MFN 06-360

CD – Revision 2 to DCD Tier 2 –

ESBWR Electrical Power –

Chapter 8 (26A6642AX, Rev. 2)
& Change List

Figure 8.1-1. Electrical Power Distribution System - One Line Diagram

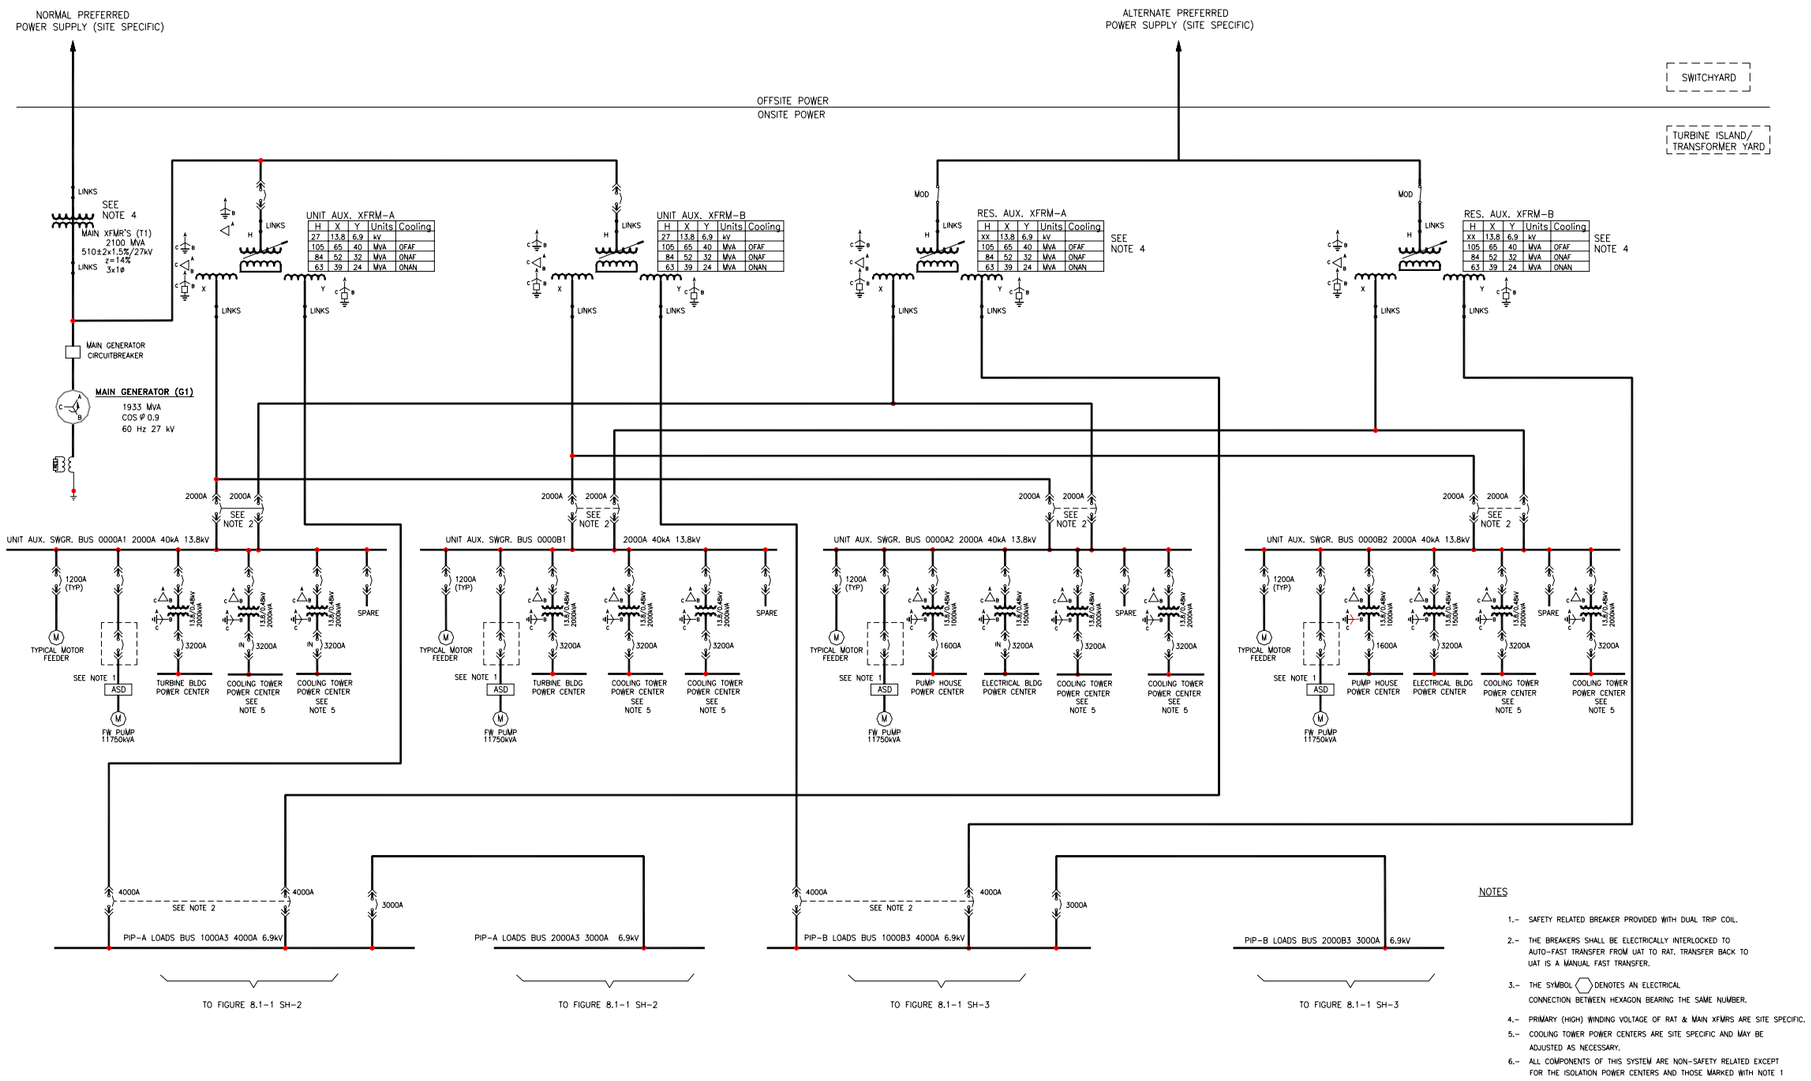
45	Figure 8.1-1, Sheet 1	Revise the dotted line to go through the drawing above the main transformers, UAT and RAT's and show "OFF SITE POWER" above the line and "ON SITE POWER" below the line. Clarification to show ESBWR standard design as "ON SITE" and OFF SITE to be site specific in design.
46	Figure 8.1-1, Sheets 2 and 3.	Editorial for PIP Bus label and show interlocks at Diesel generator feeder breaker to Normal and Alternate feeder breakers.
47	Figure 8.1-2, Sheets 1 and 2.	Redrawn for clarity.
48	Figure 8.1-3	Added second batteries, chargers and 250VDC power centers to divisions 3 and 4 to provide 72 hours of 120 VAC power with deletion of all 480 VAC safety-related loads.
49	Figure 8.1-4	Added second UPS (rectifiers, diodes, inverters, transformers, static and maintenance transfer switches and 120VAC load buses to divisions 3 and 4 to equalize load capacity and ensure 72 hour ampacity for all four divisions of safety-related power.

Figure 8.1-5. Uninterruptible AC Power Supply (Non-Class 1E) - One Line Diagram
Sh 2 of 2

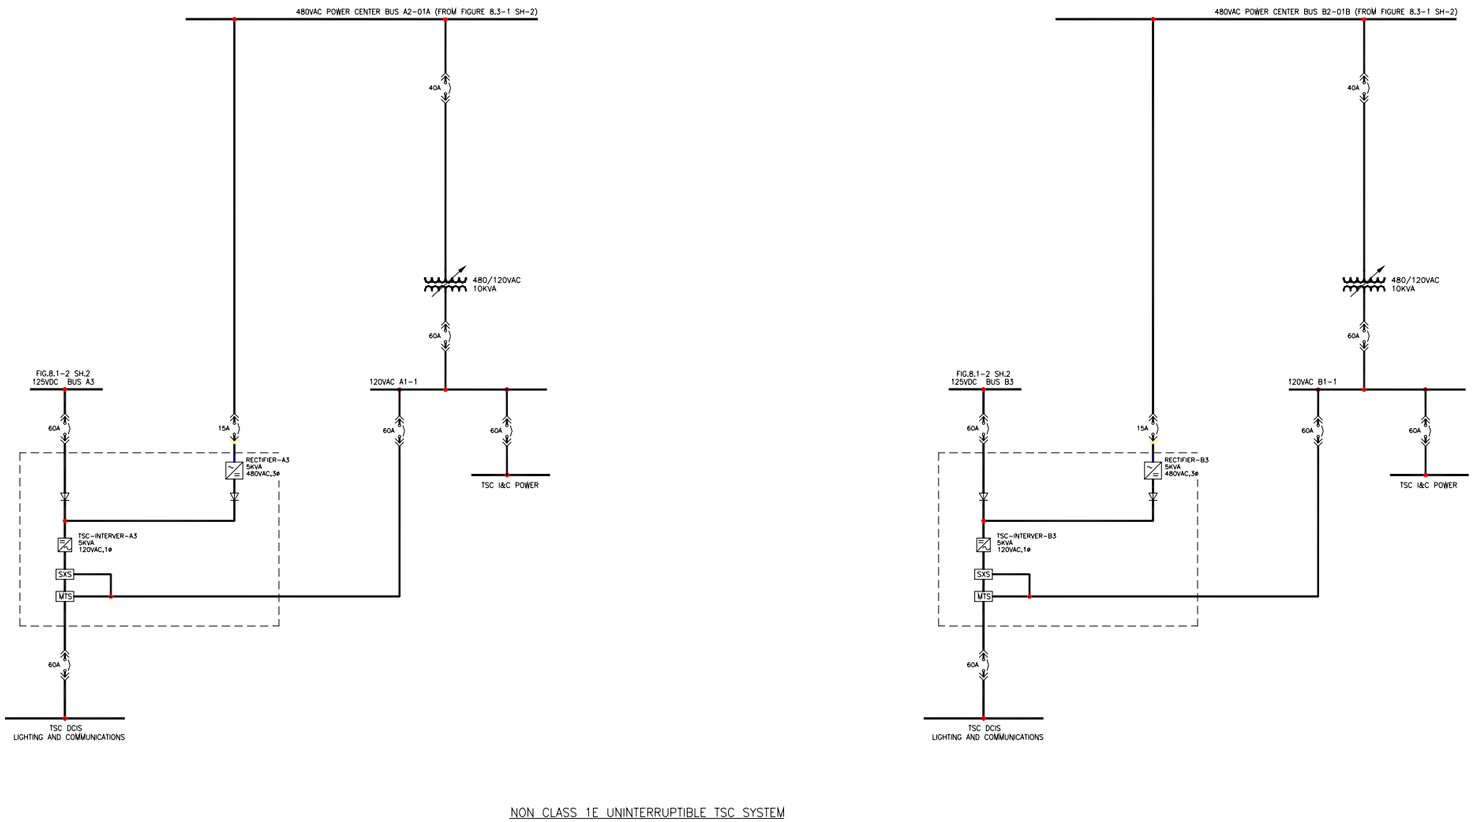
50	Figure 8.1-5, sheet 2.	Editorial correction to show correct power center supplying UPS rectifiers A3 and B3.
51	Figure 8.1-6, sheet 1 of 2.	Deleted this figure and the 32 breakers, four transformers, and associated buses that supplied diesel derived 120VAC power to the Class 1E safety-related I & C E-DCIS loads to be used as a second source of power for self-check. Power

Figure 8.1-6. Instrumentation and Control Power Supply System - One Line Diagram
Sh 1 of 1

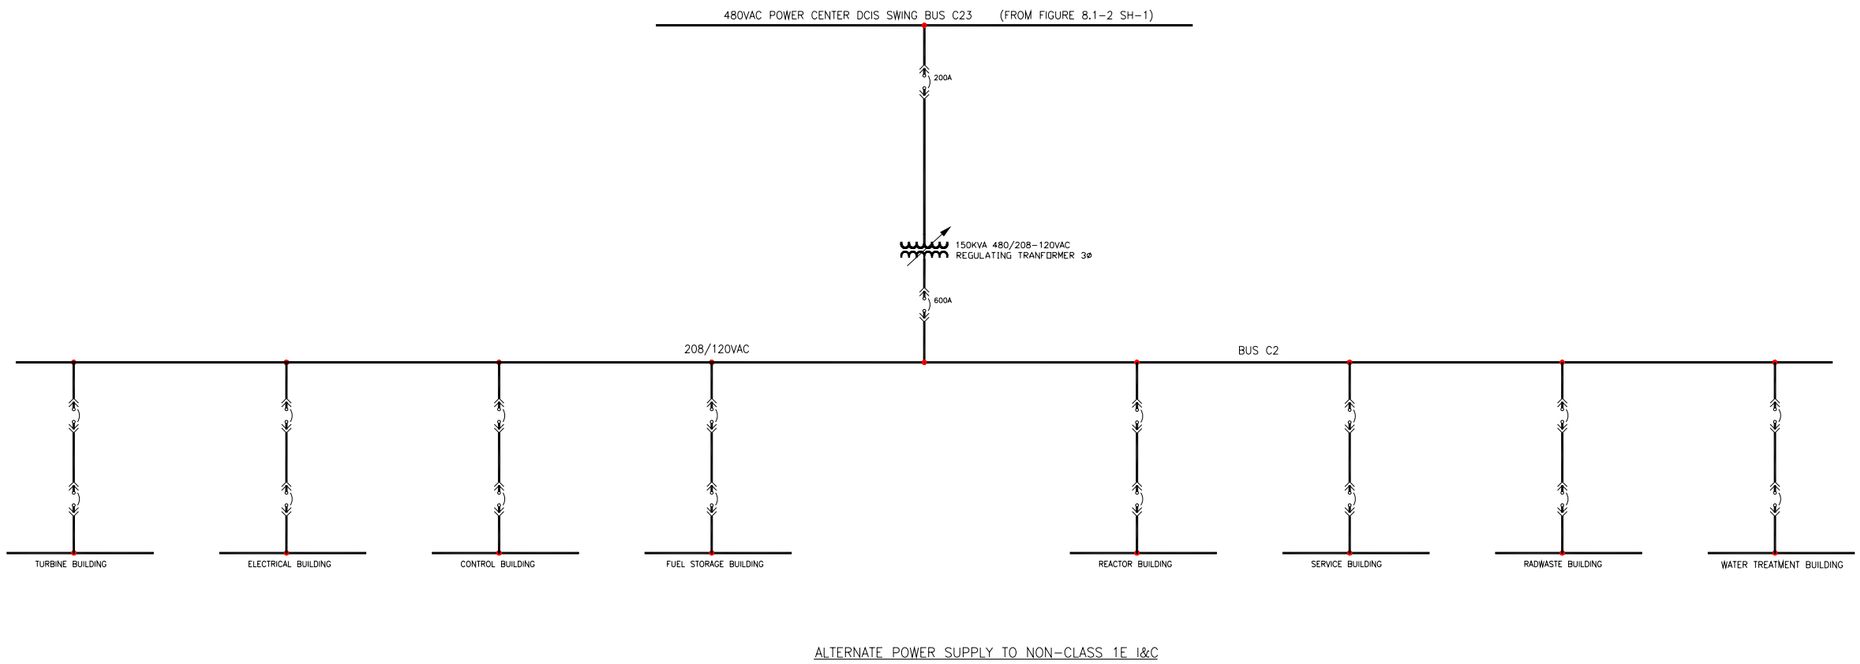
replaced with second battery of each division to ensure 72 hours of DC power without AC source required.
52	Figure 8.1-6, sheet 2 of 2.	Revised sheet number to sheet 1 of 1.
